REQ'D.	ITEM	PART NUMBER	DESCRIPTION	SYMBOL
F.E. EATON LIST OF MATERIAL				
MATERIAL				
FINISH				
THE TECHNICAL MATERIEL CORP. MAMARONECK, NEW YORK				
TITLE				
DIAGRAM, SCHEMATIC				
UNLESS OTHERWISE SPECIFIED DIMENSIONS ARE IN INCHES AND INCLUDE CHEMICALLY APPLIED OR PLATED FINISHES	DRAWN J. LESHINSKI	DATE 6/30/65	FINAL APPROVAL [Signature]	DATE 7/16/65
DECIMALS ± .05 XX ± .01 XXX ± .005	TOLERANCES	FRACTIONS ± 1/64 ANGLES ± 0° 30'	ELECT. DES. MECH. DES.	DATE 7/16/65
THE CONTENTS OF THIS DRAWING ARE THE EXCLUSIVE PROPERTY OF THE TECHNICAL MATERIEL CORP. ITS UNAUTHORIZED USE OR REPRODUCTION IN WHOLE OR IN PART IS STRICTLY FORBIDDEN.				CK1001
REV. LTR.

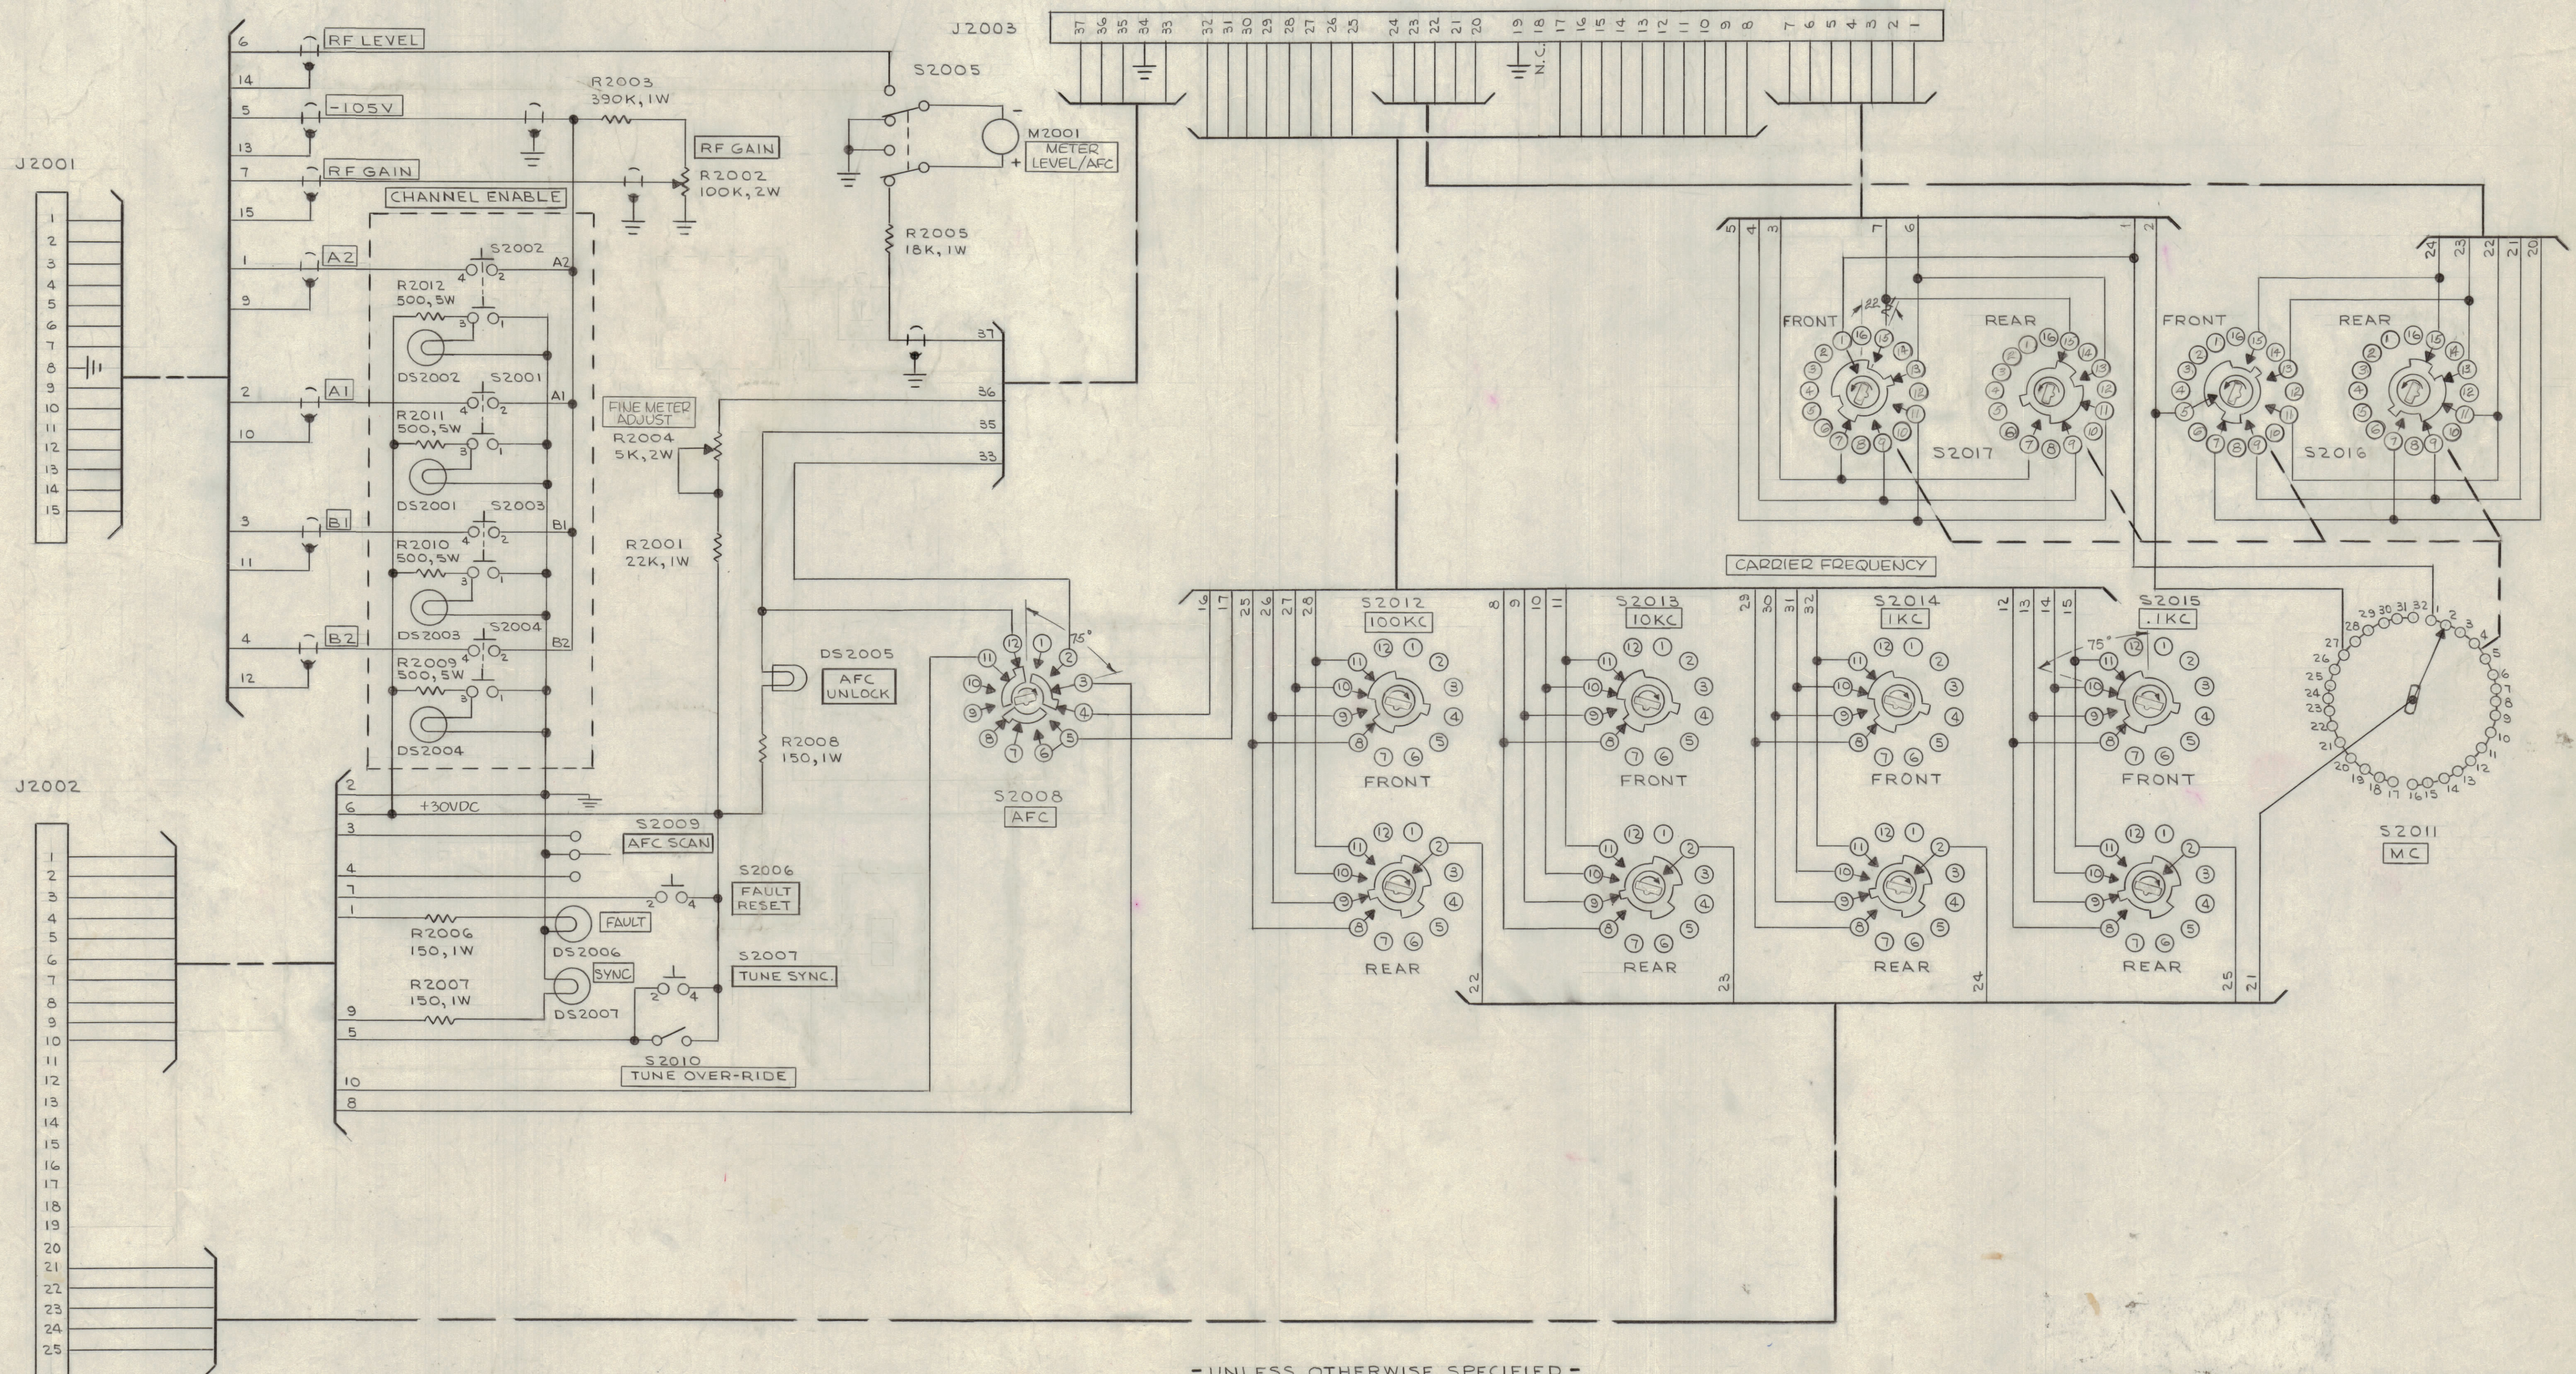
REVISIONS						
ZONE	BY	DESCRIPTION	DATE	E.M.N. NO.	DRAFT	CHKD
X1		ADDED SWITCHES S2011, S2012, S2013, S2014, S2015	7-12-65	X1	JC	NL
X2		ON S2011 MC PIN #1 WAS BREAKOUT #2, PIN #2 WAS BREAKOUT #1	7-14-65		JC	NL
X3		R2004 NOW ADDED. +30VDC ADDED TO PIN 6 J2002	7-21-65		JC	NL
		CARRIER FREQUENCY ADDED				
		ORIGINAL RELEASE FOR PROD.	7/21/65
